SSMUH Draft Zoning Bylaw Amendments Agenda Item

SSMHU bylaw - design guidelines

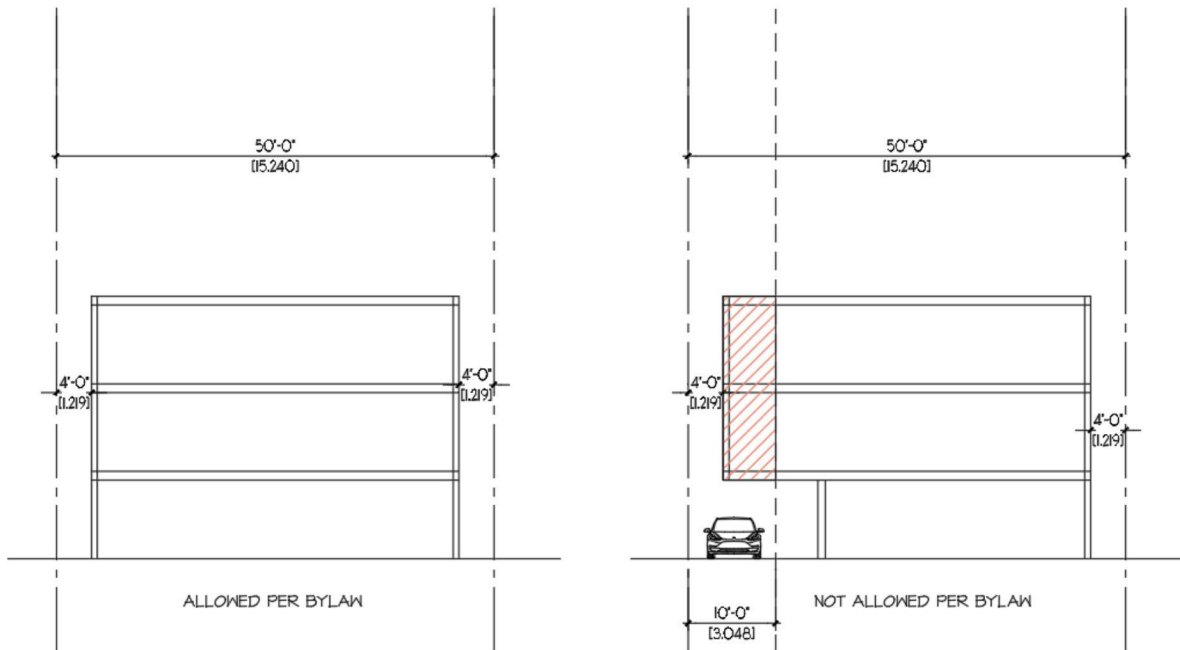
4.5m rear setback will be prohibitive, and a major deviation from province-suggested 1.5m.

In the case where Rear Yard parking is accessed from the Front Yard, no Building shall be located within 3.0 metres of the Side Lot Line within the portion of the Side Yard used to access the Rear Yard. - Planning, please consider removing this requirement because the driving aisle can be overhung on the second floor (i.e drive aisle could happen on the ground floor while building could encroach into 3m on the second and third floors.) There could also be a situation where the drive aisle would need to enter in the middle (but also from the front) and not on the side, so please just consider leaving it as 1.2m. This will self-regulate anyways, if the designer chooses to put a drive aisle on one side, then the setback will become 3m by default ('effective' setback.)

Basically, if condition on the left is allowed, then condition on the right should also be allowed (since 1.2m is allowed for buildings without parking in the back.)

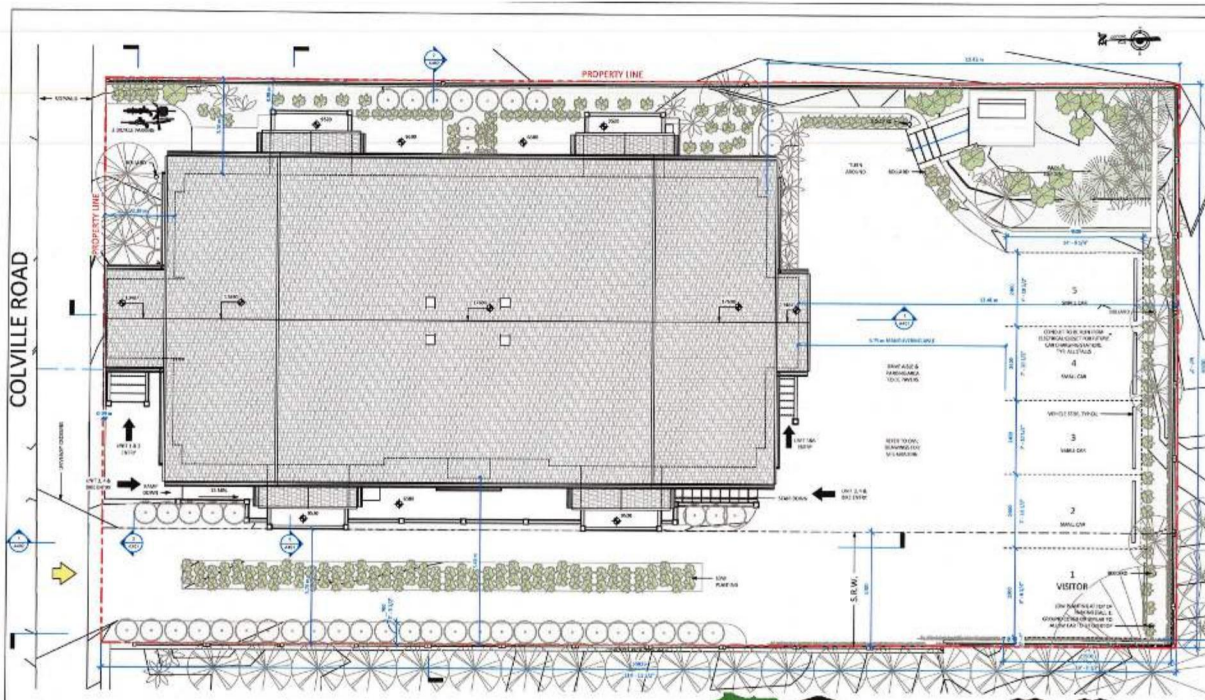
4m front setback and 4.5m rear setback - very prohibitive when combined together, and a major deviation from province-suggested 1.5m for rear and 2m for front.

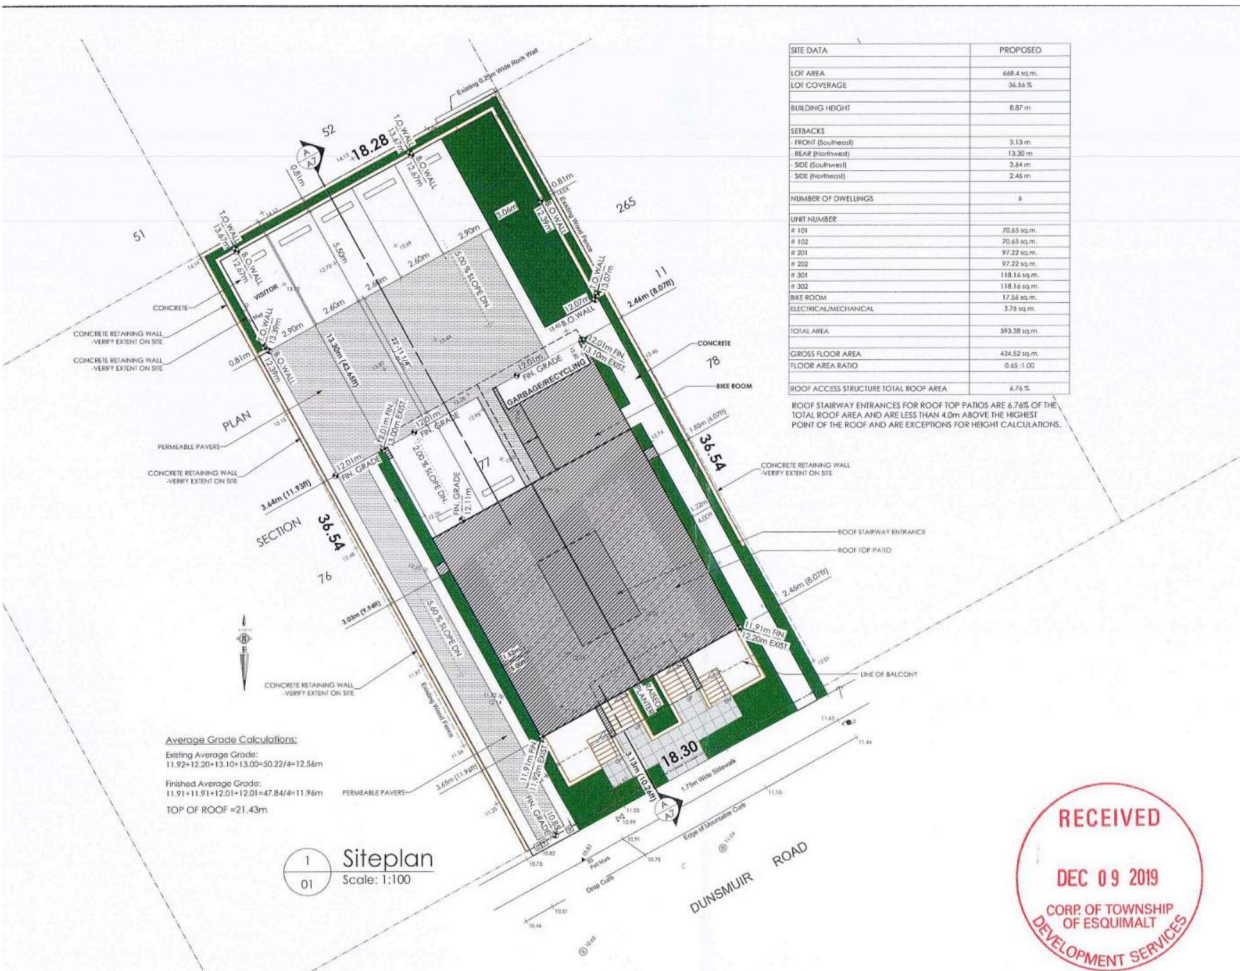
937 Colville by Ryan Jabs is a prime recent example of what most of these houseplexes will look like. That building would not be possible if a 4m setback was an expectation. Or if a private outdoor area for each unit **at grade** was an expectation. Right now every project that comes in looking like this will require variances. Will this need to go to Council then?

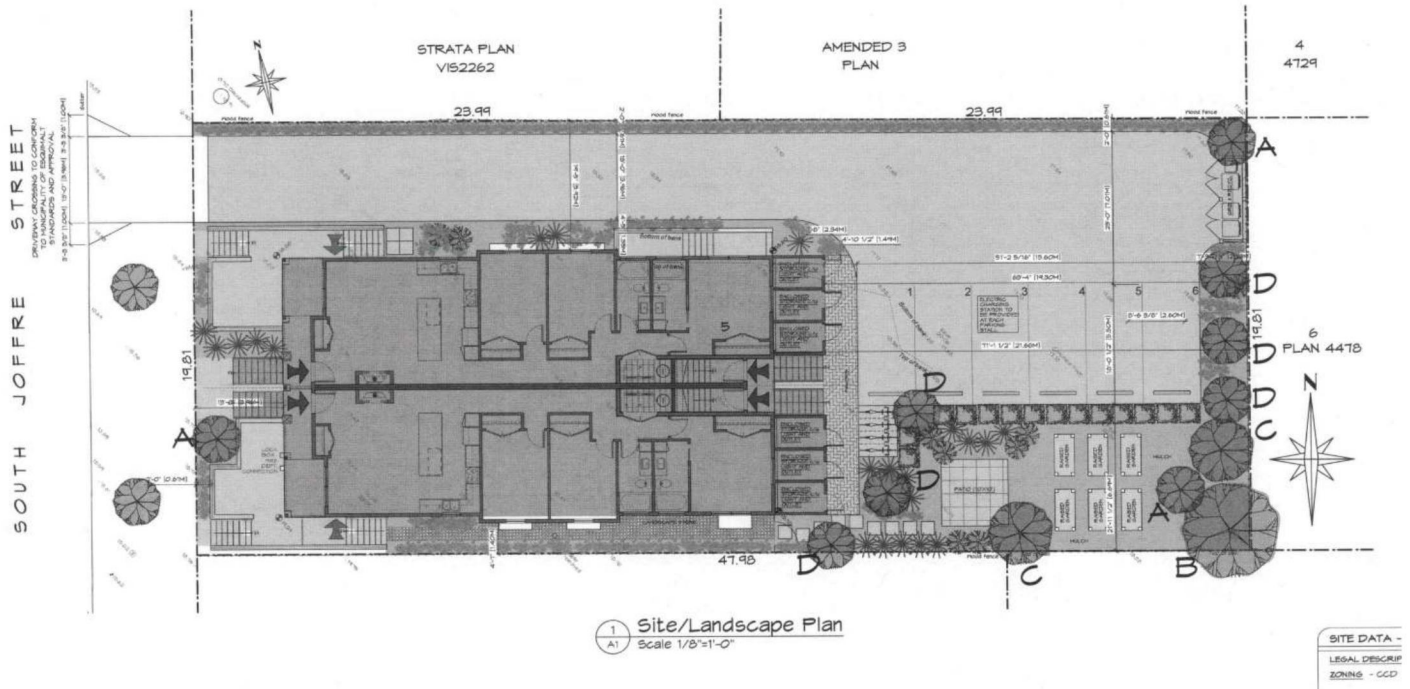
Another example is **876 Dunsmuir - 4 plex**, also would not be possible if 4m setback was an expectation (or private outdoor space at grade.)

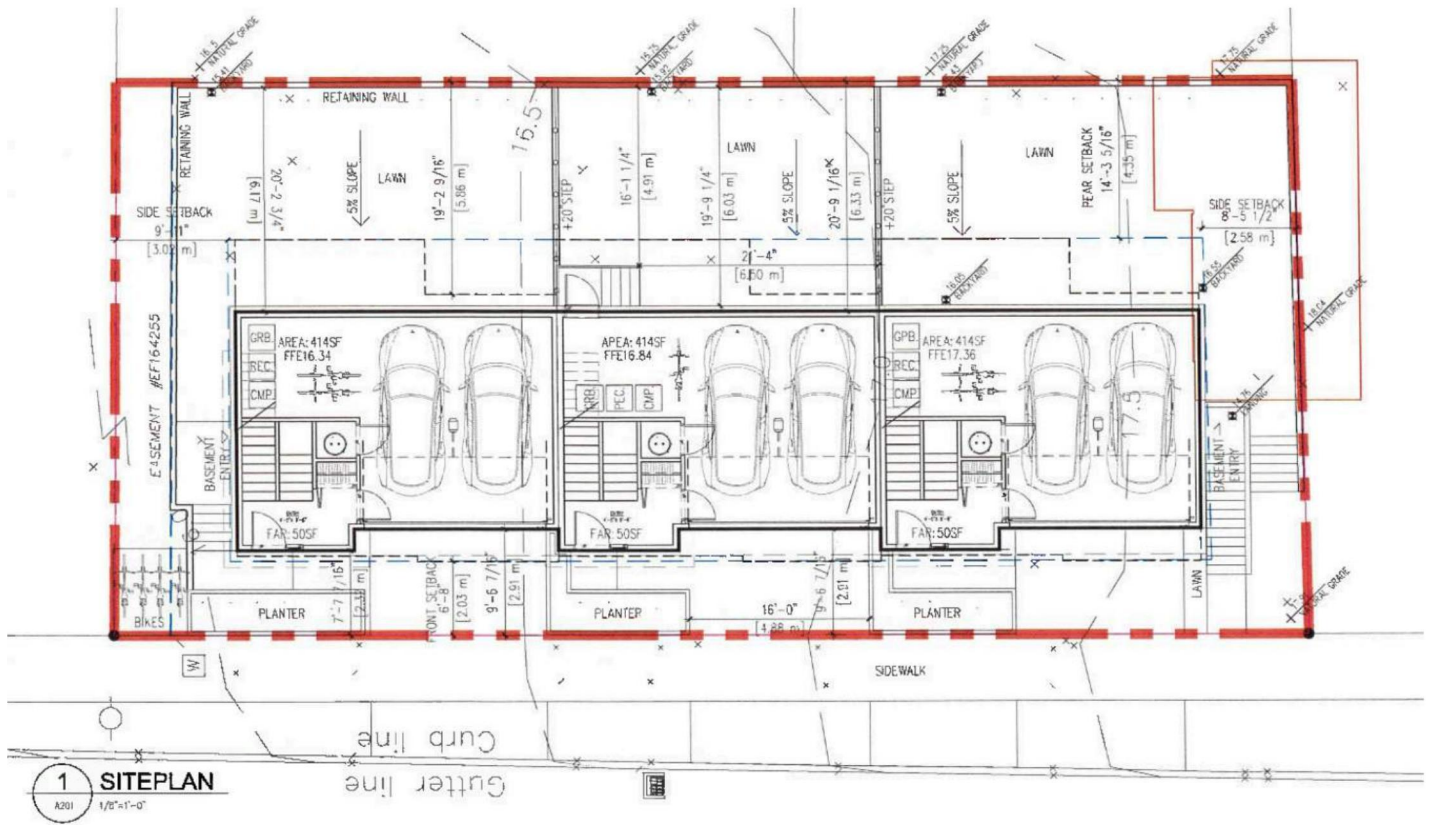
485 Joffre St. Same points as above. This one almost gets the 4m front setback (not quite) but this is also a longer than typical lot, at 160' instead of typical 110'-125' - so they have 35'-50' extra feet to play with, and still they dont propose 4m.

633 Nelson street - same as above. Though a little bit of an atypical lot/condition for Esquimalt, I would like to bring it up as an example for Council to consider walking it to get a sense of exactly what 2m front setback would feel like. Unfortunately we were not allowed to plant more trees in that boulevard, and the existing tree that we worked so hard to save was recently chopped down without warning by BC Hydro - but typically opportunities would be there to plant trees in the boulevard, and something we should 100% ask for from all new developments.
